RS-10-018
February 4, 2010

Dresden Nuclear Power Station, Units 2 and 3
Renewed Facility Operating License Nos. DPR-19 and DPR-25
NRC Docket Nos. 50-237 and 50-249

Subject: Request for License Amendment Regarding Shutdown Cooling System Isolation Instrumentation

6.0 INSTRUMENT CHANNEL CONFIGURATION

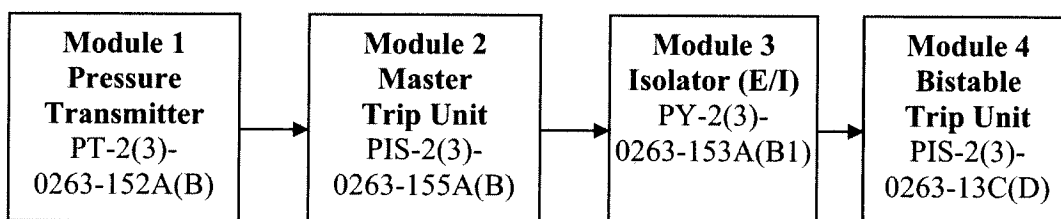
The new pressure interlock instrument configuration will also consist of two trip strings, with two trip channels per trip string. Each trip channel will receive a pressure signal from separated pressure channels that measure the reactor pressure from condensing chambers that are located on opposite sides of the reactor vessel. Configuring the trip strings to use a pressure signal from the two different condensing chambers will prevent a sensing line failure from initiating the isolation/interlock permissive, since only one trip channel in each trip string will be initiated.

Each trip string will receive a pressure signal from two pressure transmitters (i.e., the safety related Analog Trip System (ATS) panel and the non-safety related feedwater control system). This configuration, which is described in Section 6.0 of Attachment 4, will ensure that a complete failure of the ATS panels or the feedwater control system will not initiate the permissive, since only one trip channel in each trip string will be initiated.

6.1 Instrument Loop 1:

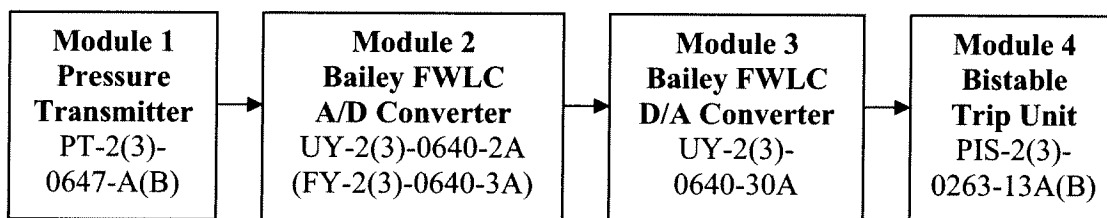
- PT-2(3)-0263-152A: U2(3) Reactor Wide Range Pressure
- PT-2(3)-0263-152B: U2(3) Reactor Wide Range Pressure

Per references 3.7.1 and 3.3.3, the following diagram shows the subject instrument loop based on the schematics:
